# Changing assigned Class through DLL v101

do\_update\_pse\_assigned\_class

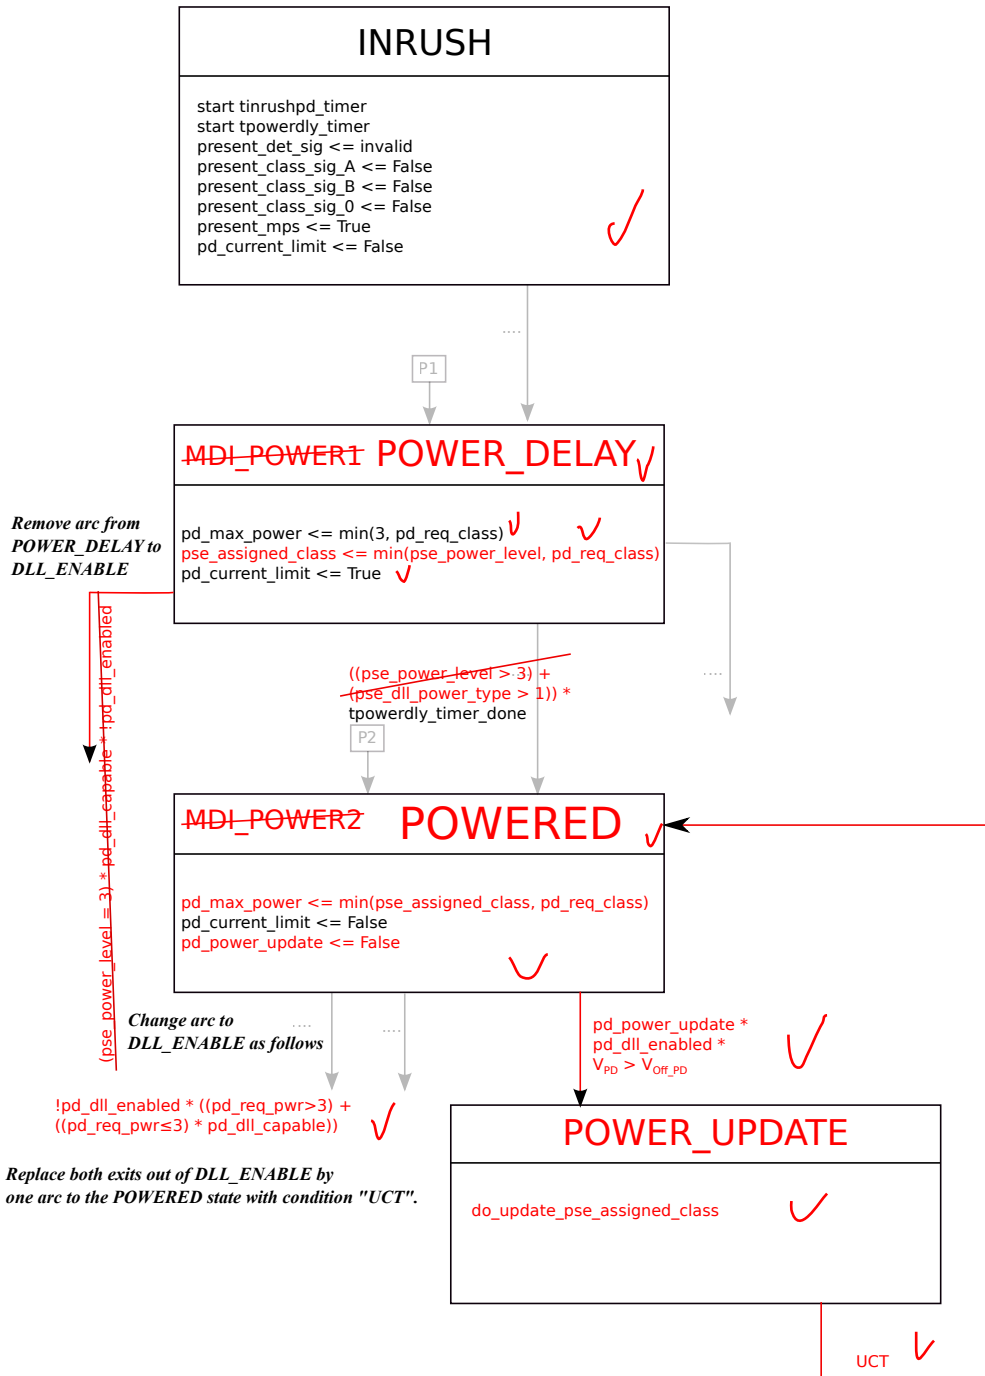
append to teh end of this text: "to lower values than the initially set by Physical Layer classification"

This is true, but is already handled by a SHALL, why do we keep repeating this ?<sub>2</sub>

Power demotion, not ext. pwr.

### 33.3.6 PD classifications

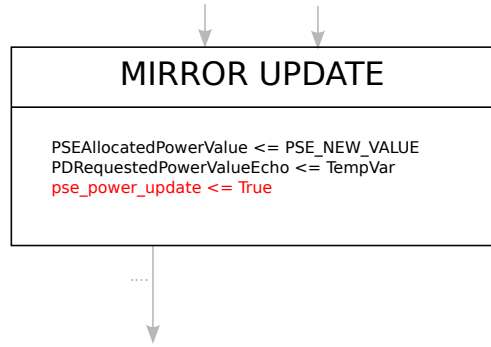
After a successful DLL classification, the assigned Class changes depending on the value of PDMaxPowerValue variable, as defined in Table 33–24. A PD may be able to get a Class assigned that is higher than its requested Class, however it is not permitted to draw more power than what corresponds to the PDs requested Class.

Why to allow it in the text???

Fair point, I will change/delete it.
